Planning Commission Staff Report

Petition: **P.Z. 05-2022 Gateway Golf Center (Gateway Studios, LLC)**: A request for a zoning map amendment from the “PC” Planned Commercial District to a new “PC” Planned Commercial District for 22.78 acres located on the north side of Outer 40 Road (17V630059).

Re: PZ 05-2022 (17795 N. Outer 40 Road) – Response Letter
(Stock Project No. 221-7165)

Figure 4: Preliminary Development Plan

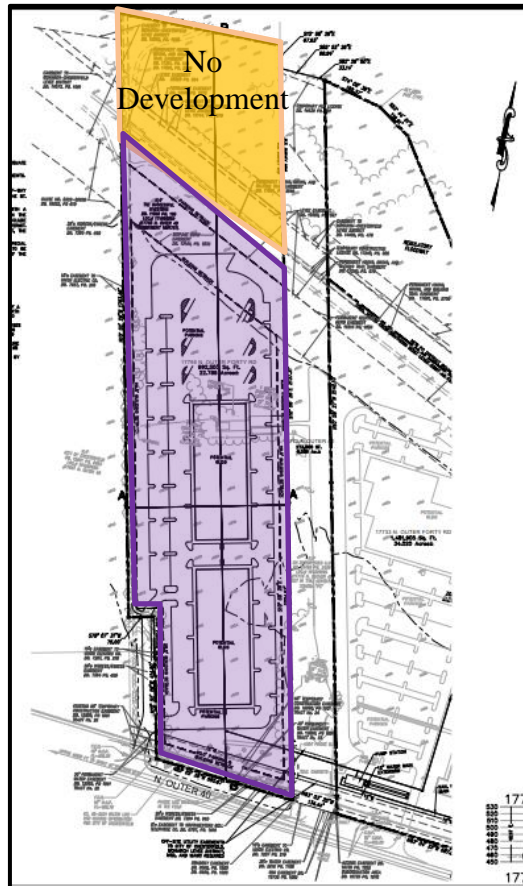
Concerns were raised about some of the proposed permitted uses. More specifically permitted uses; Arena and stadium, Grocery-Community, Grocery – Neighborhood, Financial Institution – Drive Thru, and Restaurant – Fast Food, Drive thru were discussed and recommended removing from the requested uses. Please provide an updated list of permitted uses eliminating the discussed uses.

Discussion was held regarding an existing road/cross access easement that goes along the base of the Levee. More specifically, the discussion was that there is no existing cross access easement that leads to the middle property. City requires a cross access easement to these new developments. Please provide information on the discussed cross access easement.

Response: Provided updated project narrative and requested permitted uses.

Response: This Development will be secured with fencing and isolated to its own specific use. A 50' ft wide ingress/egress utility easement exists on the east side of our 17733 N. Outer 40 Road Property. In addition, a 25' wide ingress/egress easement exists along this property's western property line. The only "Cross Access" that may be considered is with the City of Chesterfield Property to the West.

PRELIMINARY DEVELOPMENT PLAN

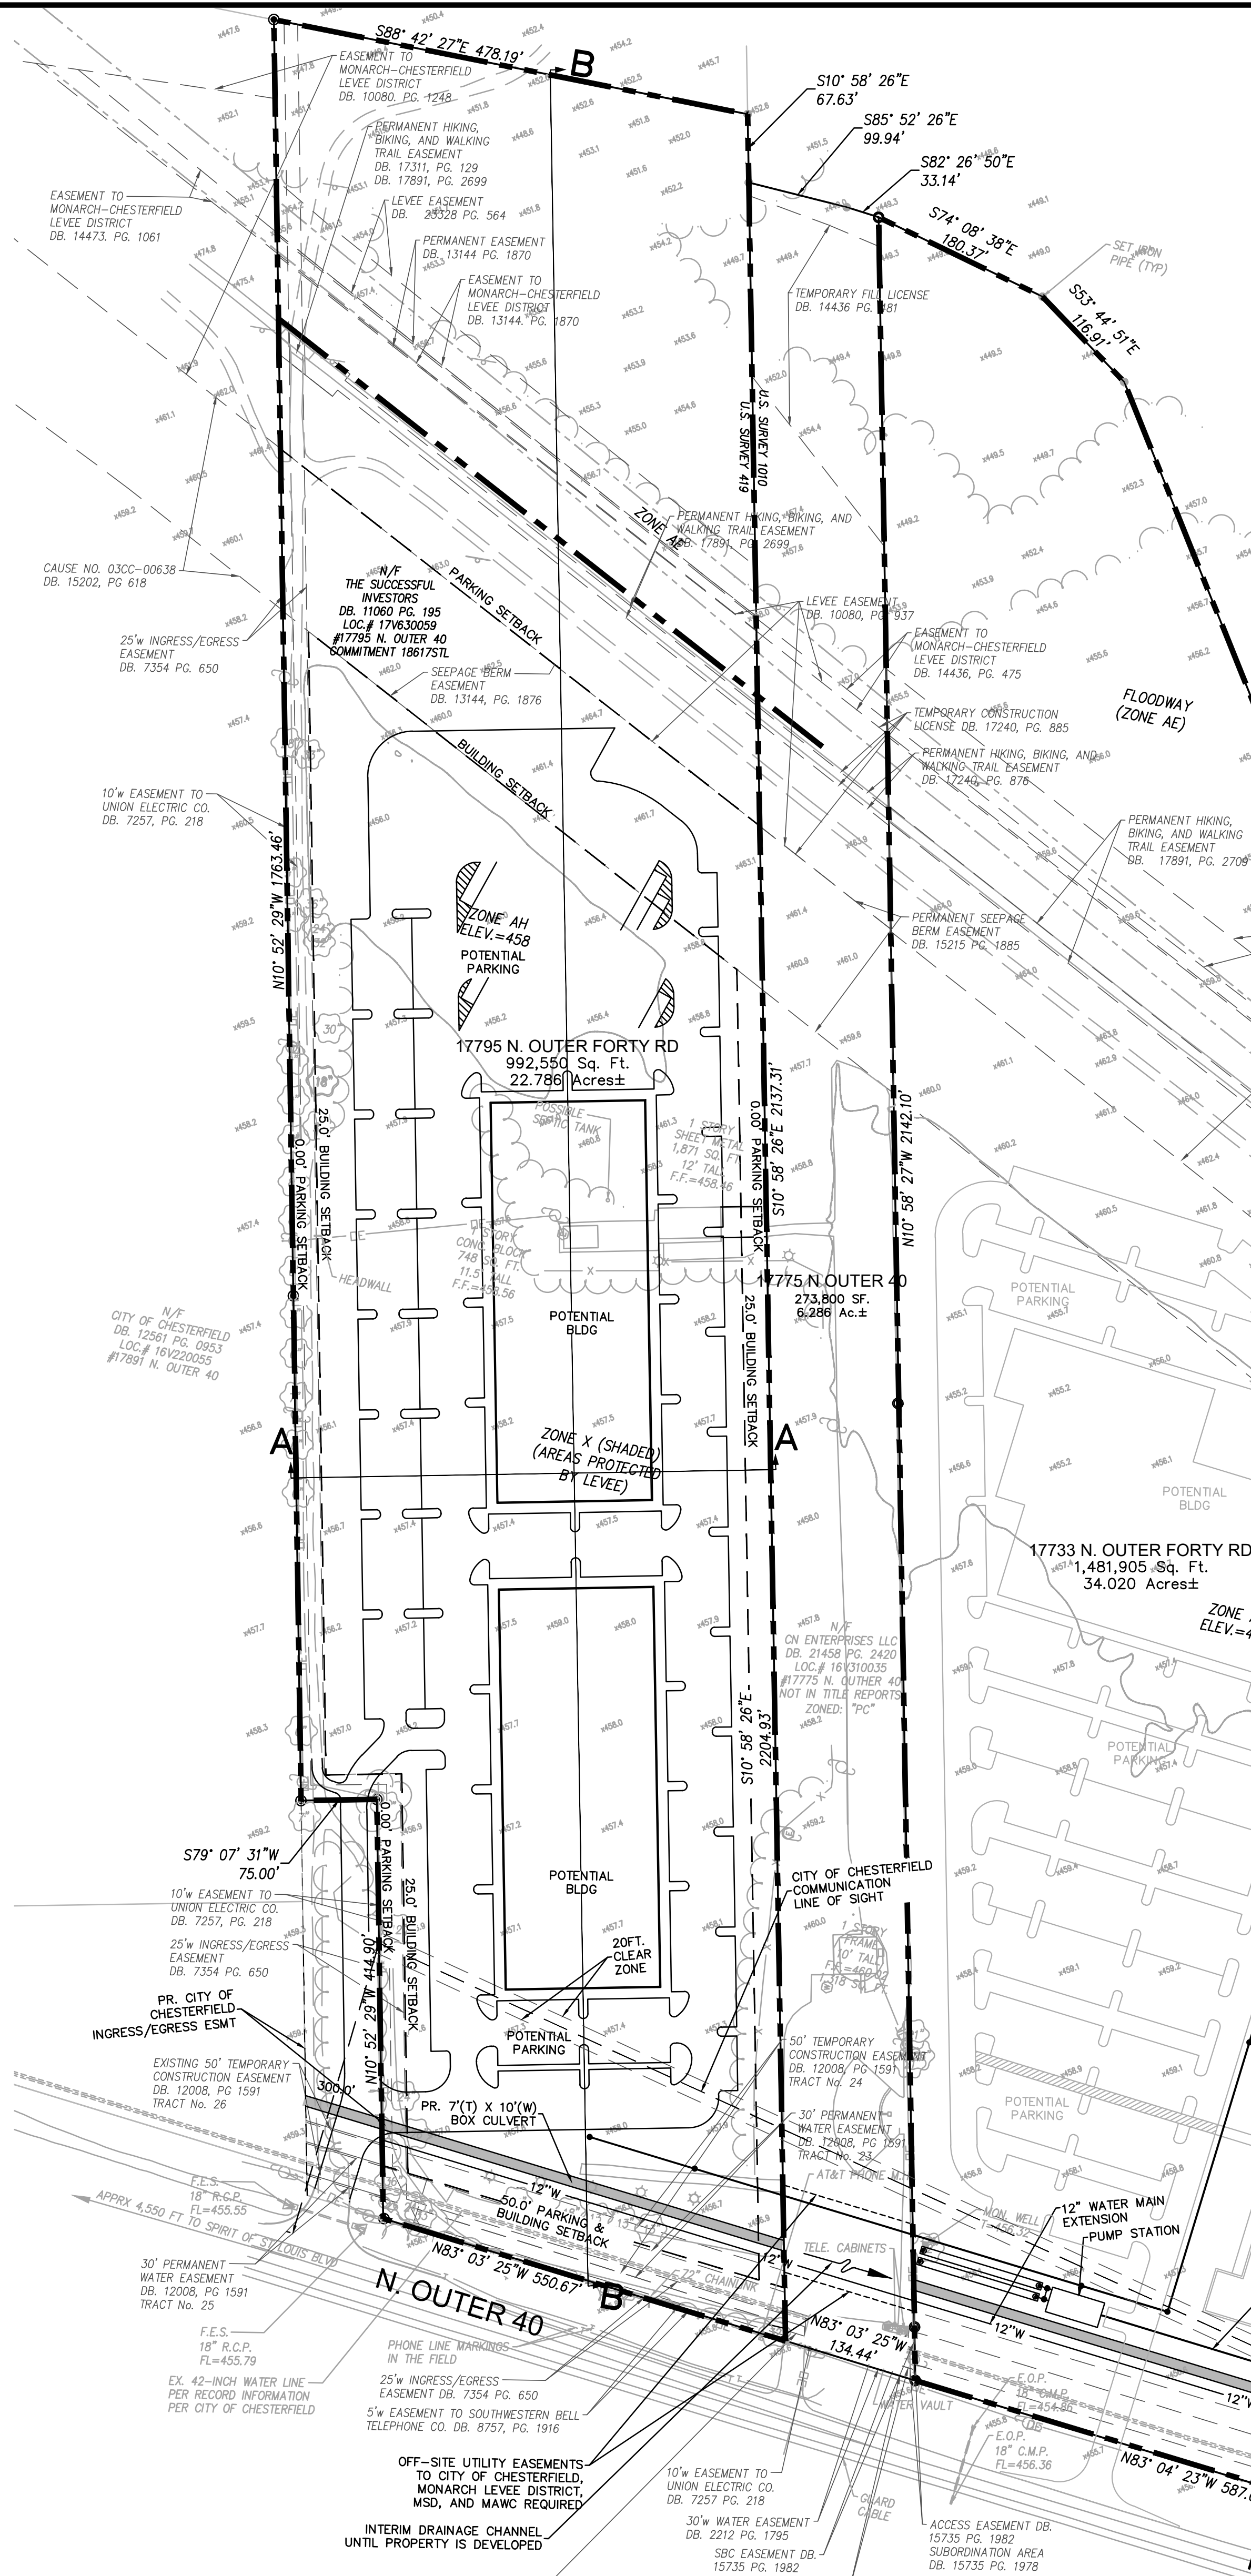
1. It is understood that the proposed entrance as shown on the Preliminary Plan will serve the City's property, the development, and the existing 25-foot-wide ingress/egress easement. Since there will need to be an easement on the City's property to cover this, please depict and label the proposed easement on the Preliminary Plan.

2. For the City of Chesterfield communication line of sight, a 20-foot-wide clear zone centered on the alignment shown is required. Anything located in the clear zone would need to be under 30 feet in height. The current preliminary plan only depicts a 10-foot-wide clear zone. Please revise the plan to provide a 20-foot-wide clear zone.

Response: A proposed Access Easement from the City of Chesterfield has been added to the Preliminary Site Development Plan.

Response: We have revised the Preliminary Development Plan to comply w/ 20-foot Wire Clear Zone.
